ADDENDUM NO. 2

Project: Town of Gibsonville – Hwy 61 Waterline Connector
AWCK Project No. 23030
NCDWI Project No. SRP-D-134-0220

Date: December 29, 2025

06/02/25	HWY 61 WATERLINE CONNECTOR PLAN AND PROFILE STA. 72+00 TO STA. 84+00	JOB NO. SHEET NO. OF: 20
P FILE: :/23030BASE		
WN BY: JBP		
CKED BY: SBM

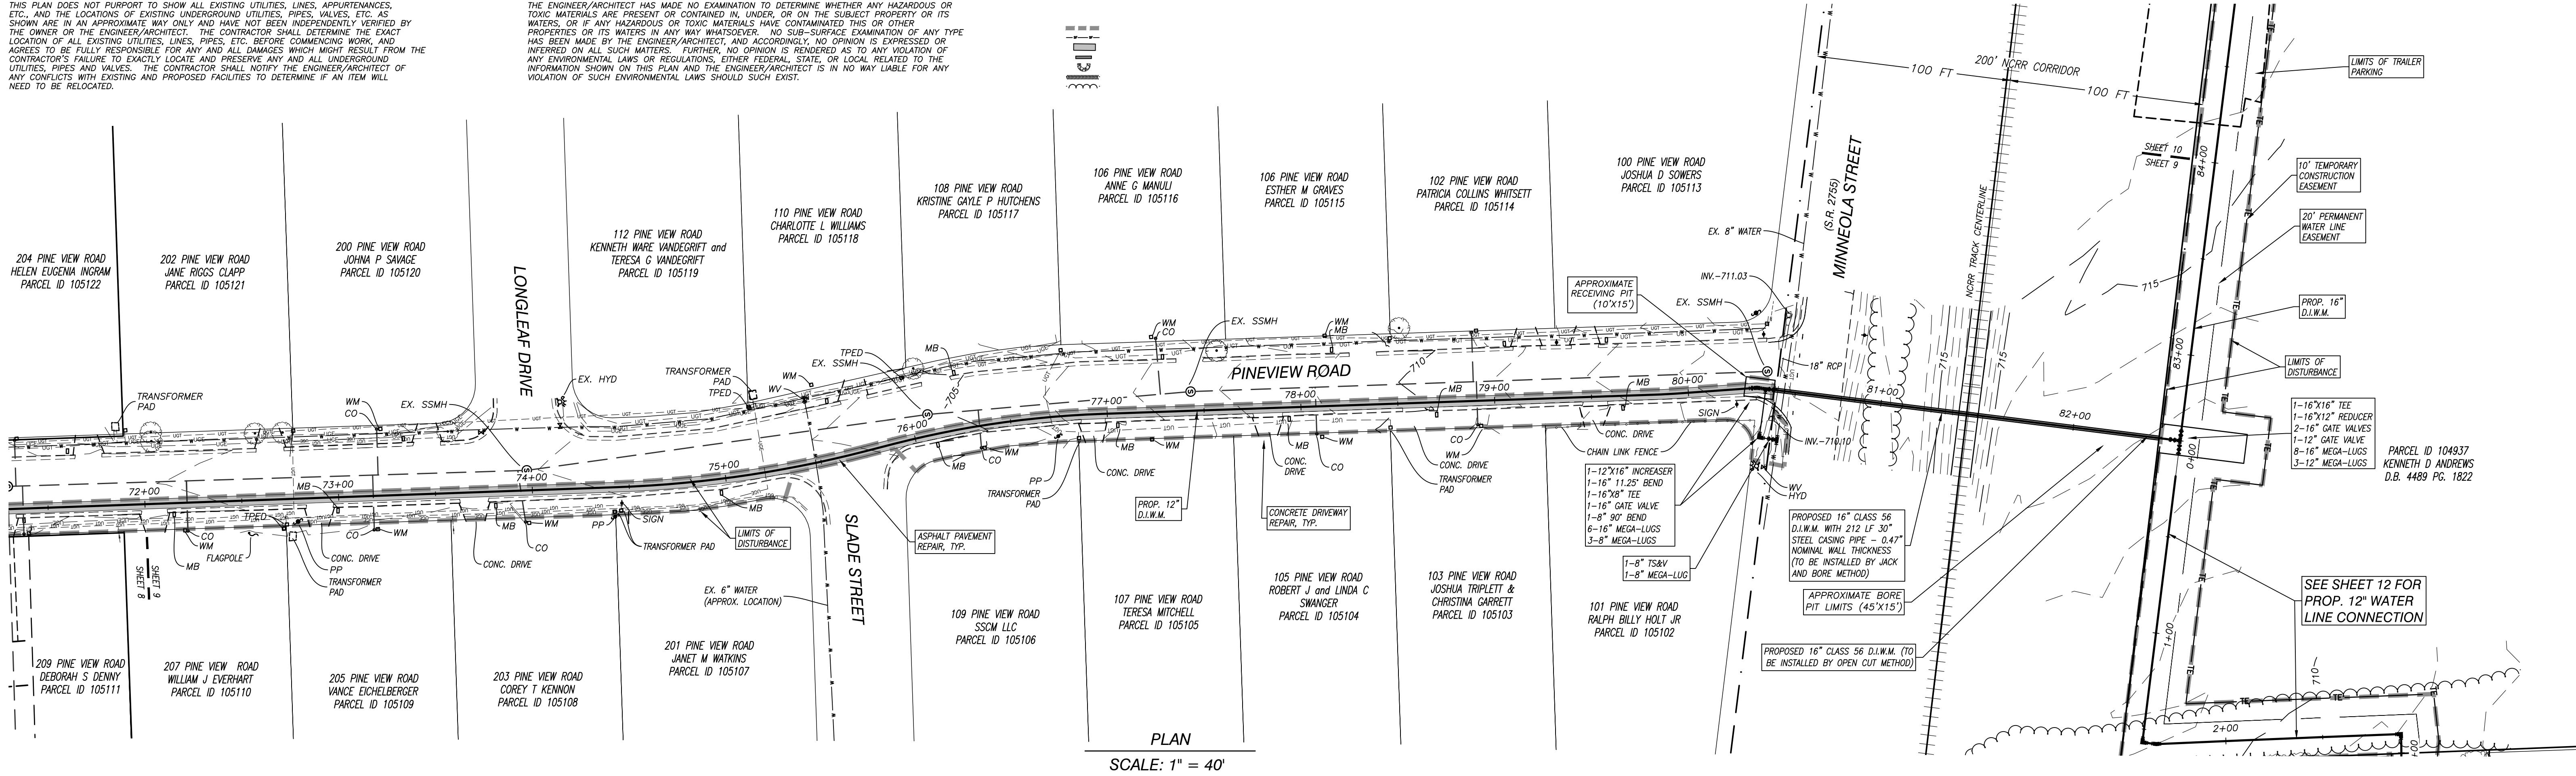
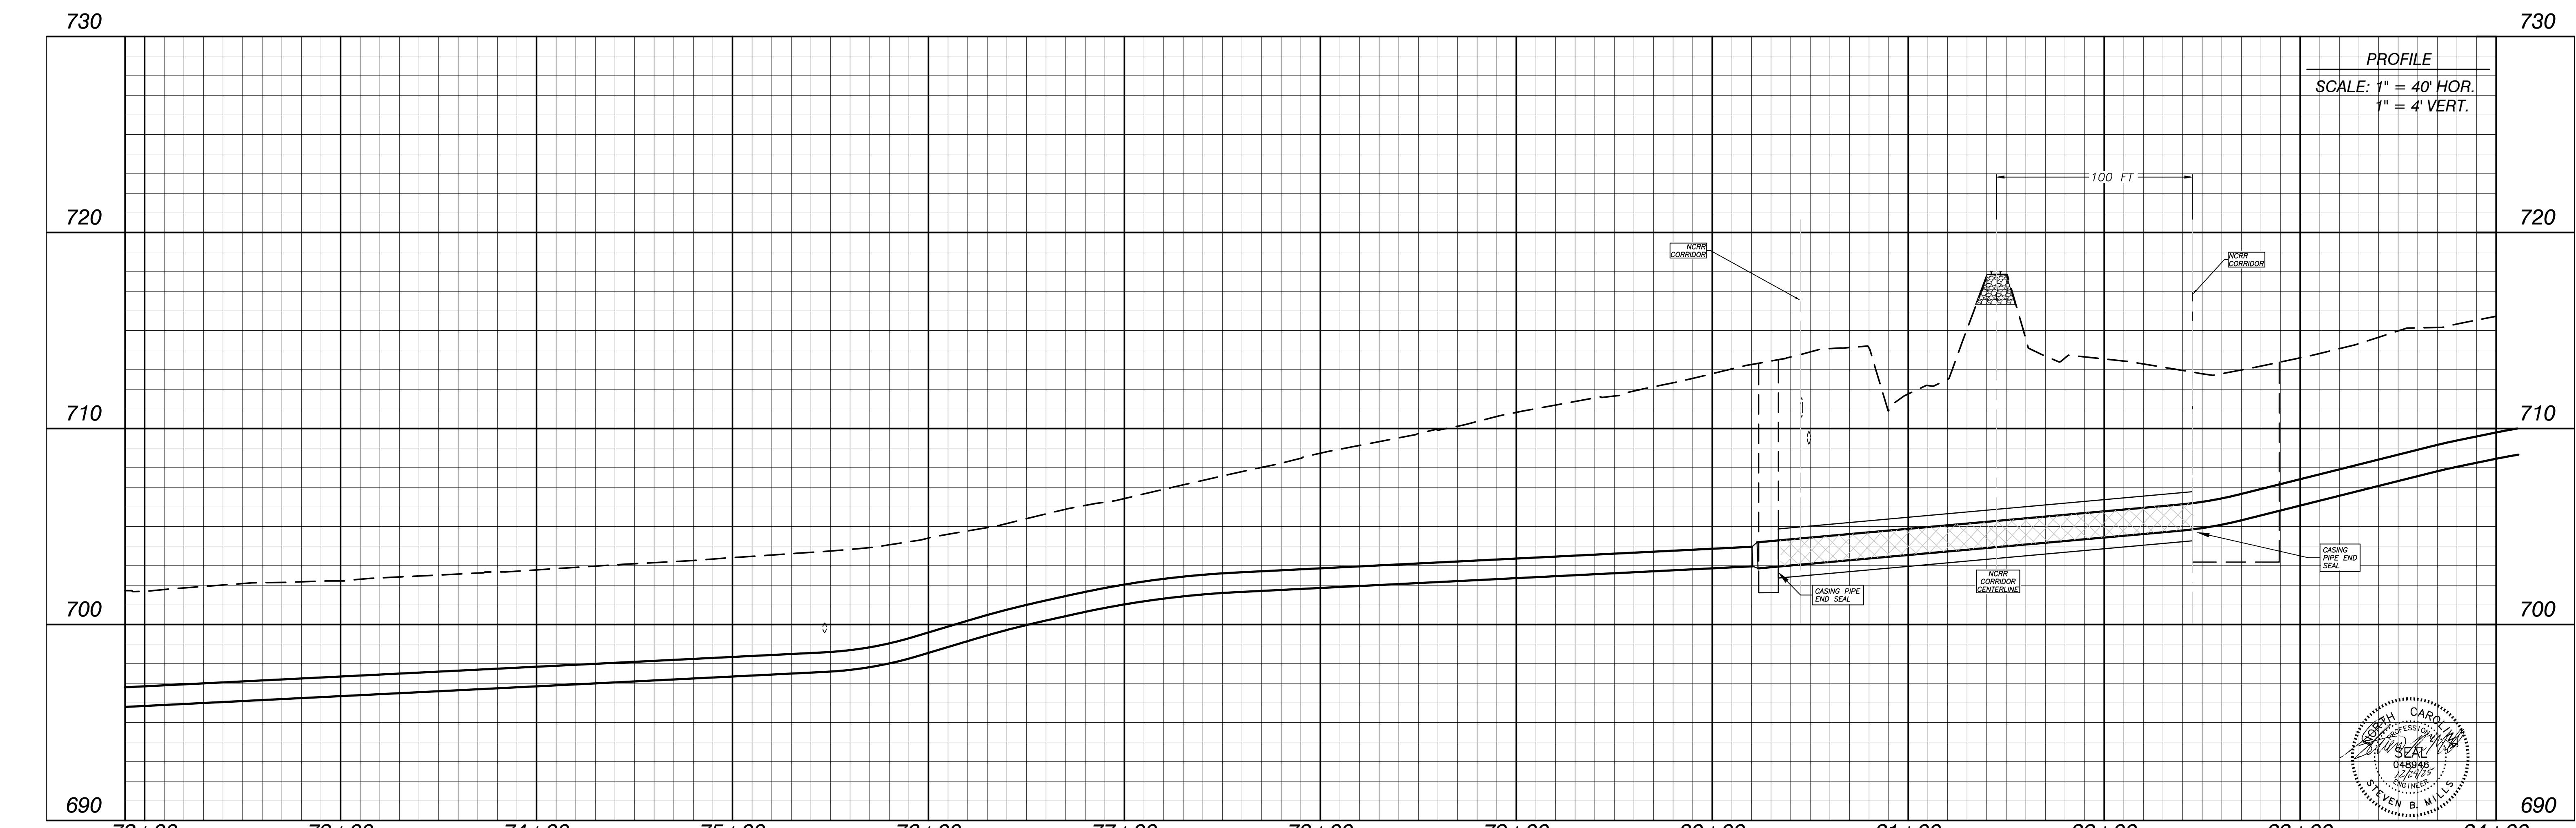
11 – Plan Sheet #9

Revision: Updated Plan Sheet #9 is included, which accurately shows the bore pit location and jack and bore quantity. Previously this bore was shown correctly in the profile and bid form quantities, plan view now updated to show the location of the bore bid outside of the NCRR corridor, lengthening the jack and bore previously shown in plan view.
